RE: Dominion Bremo Power Station VPDES Permit No. VA0004138: Revised Notice of Planned Change

Enclosed is Revision 3 to the Notice of Planned Change (NPC) concerning the East Ash Pond Stormwater Management Phasing Plan that was transmitted to you by cover letter dated December 15, 2016. Revision 2 of the NPC, submitted January 20, 2017, has been revised as follows:

EAST ASH POND EXCAVATION STORMWATER MANAGEMENT PHASING PLAN

FIGURE 2

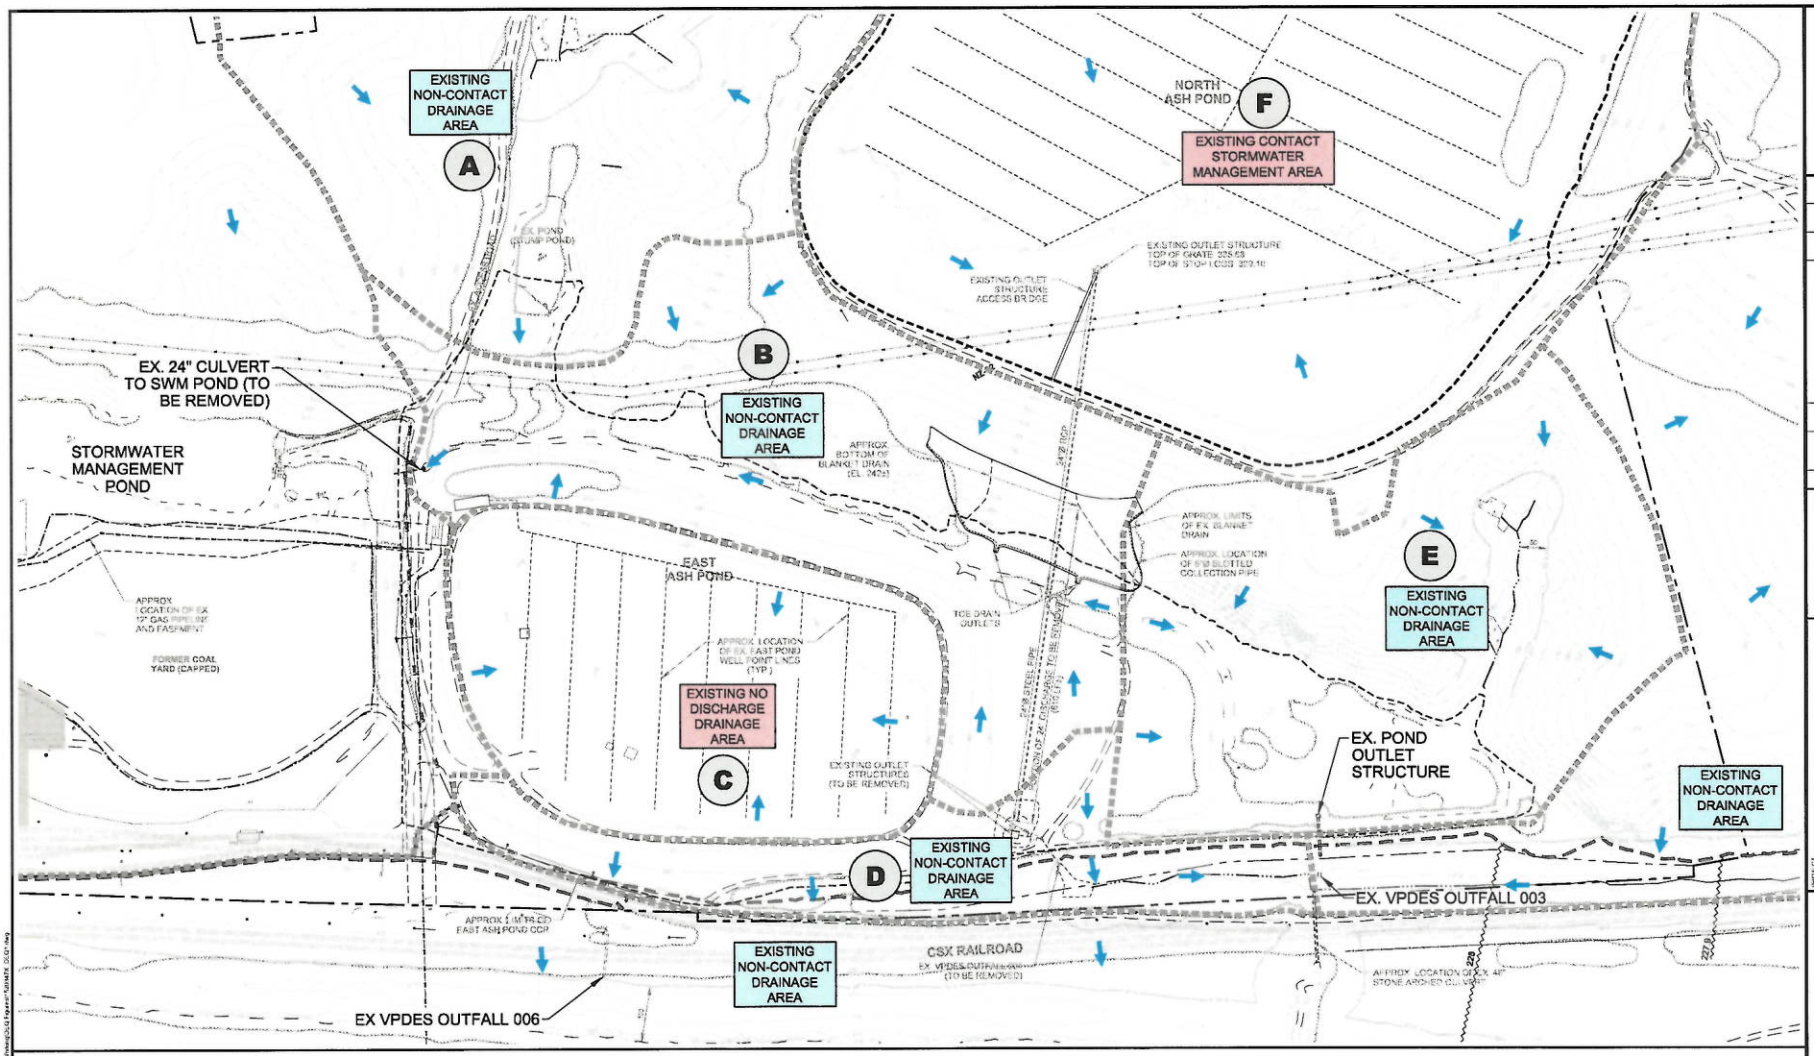
- A new contact stormwater area B2 has been added to receive drainage from the new access road to the North Ash Pond. The collected water will be directed to the CSWTS.
- The existing Stormwater Management Pond has been identified as a location that may received collected non-contact stormwater.
- Narrative was added to recognize that excavation in the Phase 4 area may begin during the excavation in the Phase 3 area in preparation for the North Ash Pond toe excavation activities.
- Narrative was added to recognize that excavation in the Phase 5 area may occur in conjunction with excavation of the Phase 4 area.

FIGURE 3

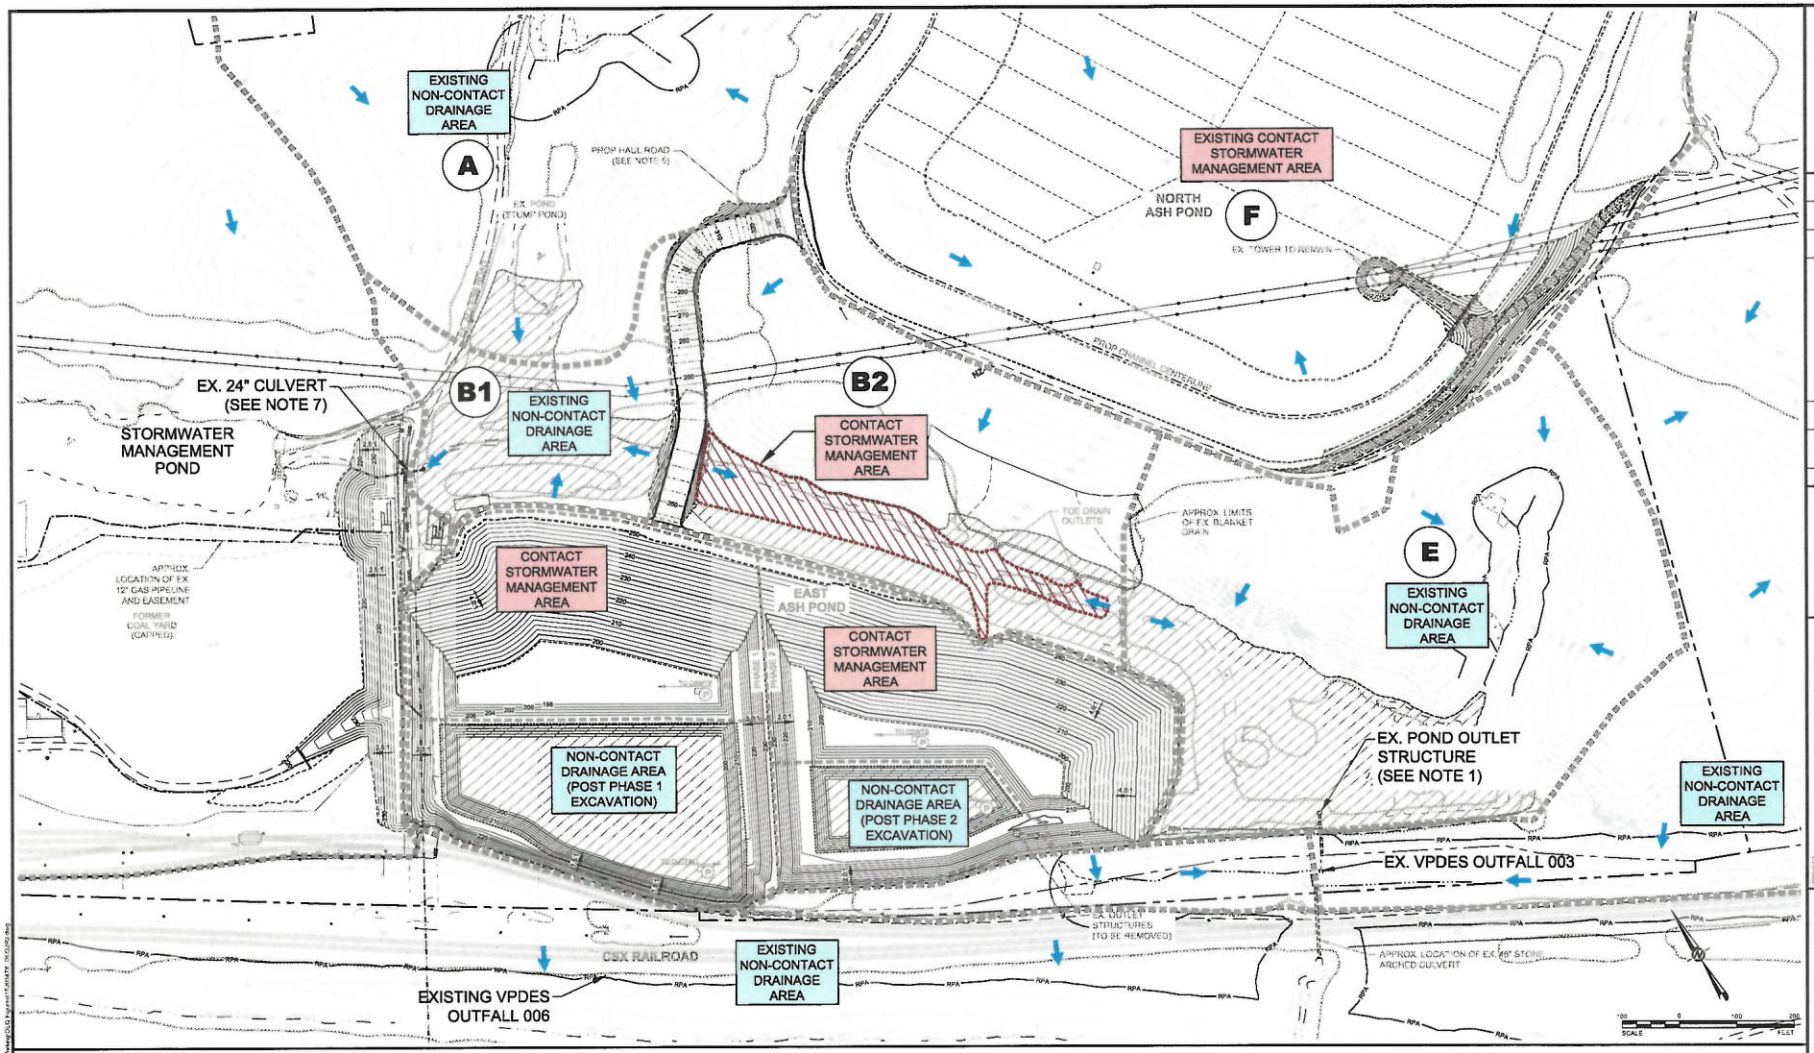
Prior to the initiation of CCR excavation activities, a haul road will be constructed connecting the NAP and the EAP. The road will be graded to divert stormwater that contacts the road to a designated contact stormwater management area located in Area B2. The contact stormwater will then be pumped to the CSWTS.

The NAP toe drain water will continue to drain into Area B2 and ultimately discharge into the contact stormwater management area and be pumped to the CSWTS.
